RE: Notice of Violation, Mallinckrodt US LLC, Bureau of Remediation and Waste Management

AMENDED NOTICE OF VIOLATION

**Subject: Plant Area CMI Plan, Concrete and Utility Removal, Addendum 5
Orrington Remediation Site
Orrington, Maine**

PLANT AREA CORRECTIVE MEASURES IMPLEMENTATION PLAN
CONCRETE AND UTILITY REMOVAL ADDENDUM 5
ORRINGTON REMEDIATION SITE
ORRINGTON, MAINE
AUGUST 2025

Plant Area Site Plan of Approximate Locations of Visible Hg and Soil with Hg > MPS, Except the Former Cell Bldg Area, March 7, 2025

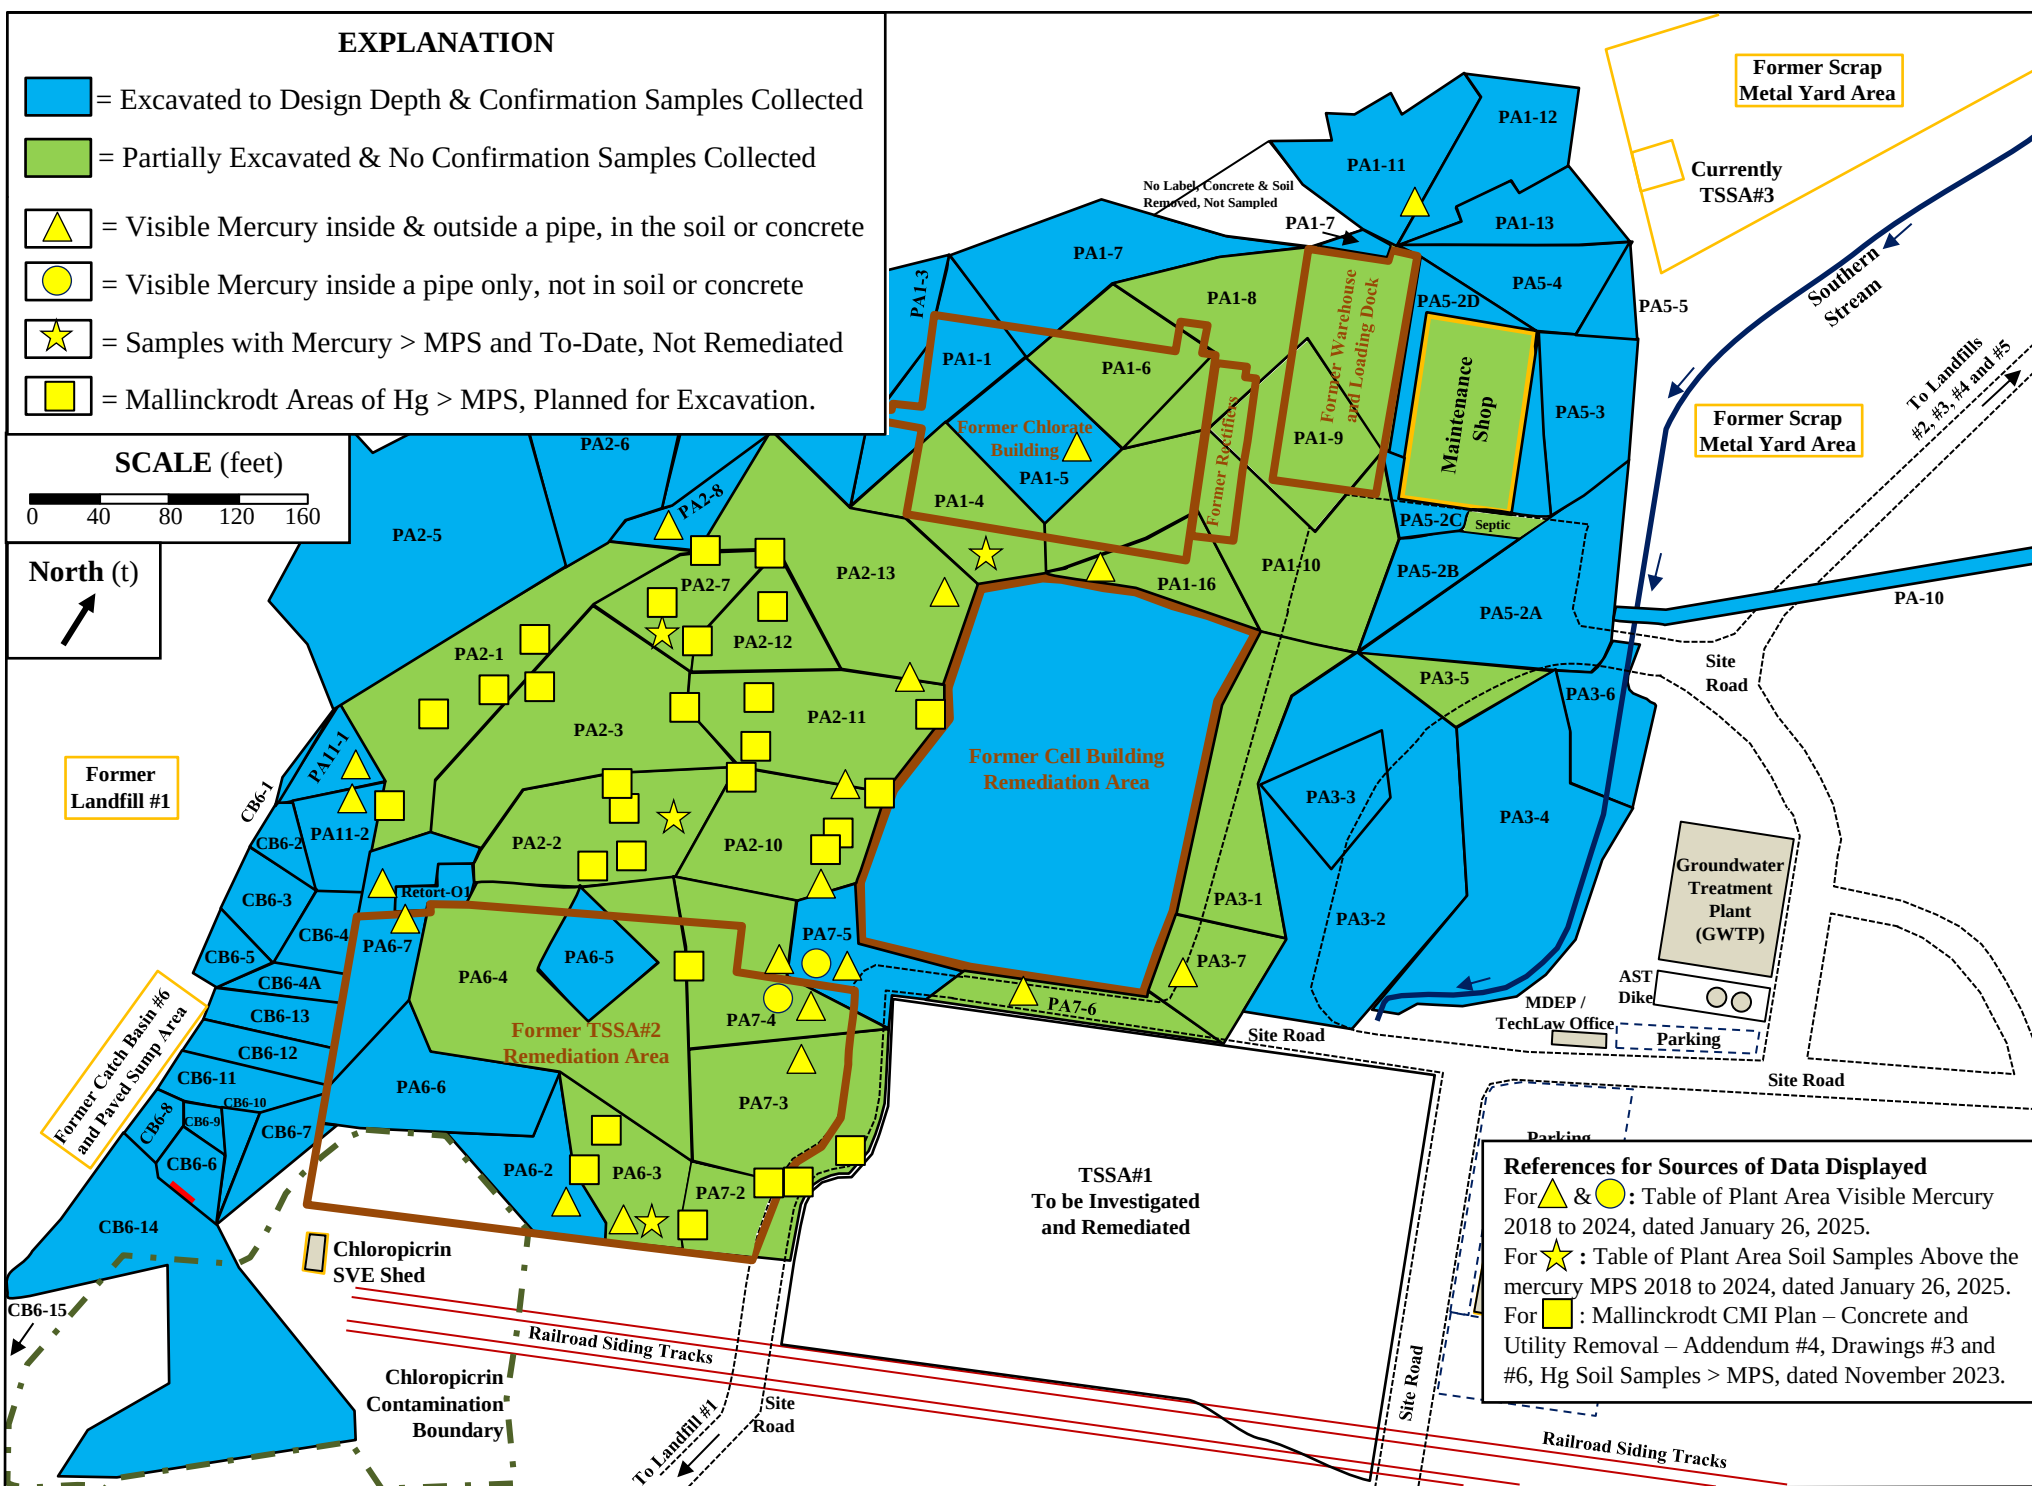
20. The DEP determined that Mallinckrodt's November 2, 2023, Plant Area CMIP was non-compliant with the DEP Orders and the DEP's June 2, 2023, letter because the Plant Area CMIP did not address remediation of all soils exceeding the mercury MPS at the Site, as required by the DEP Orders.¹³

¹³ See Plant Area Site Plan of Approximate Locations of Visible Hg and Soil with HG > MPS compiled by TechLaw, March 7, 2025.

evade this clear requirement. Indeed, on December 20, 2024, after failing to comply with the DEP Orders since at least February 5, 2024, when it was required to submit a compliant Plant Area CMIP, Mallinckrodt sent a petition to the BEP requesting that it be relieved of its responsibilities under the DEP Orders, including its responsibility to meet the MPS set by the DEP Orders. Contrary to Mallinckrodt's contentions, the Site is still a threat to human health, safety and the environment. Soil in the unremediated portion of the Plant Area presently contains visible elemental mercury and is above the required MPS.¹⁶

1. Within 30 days of receipt of this NOV, submit for the DEP's review and approval a detailed work plan to remove all solid material above the Site MPS from all unremediated areas within the Plant Area.
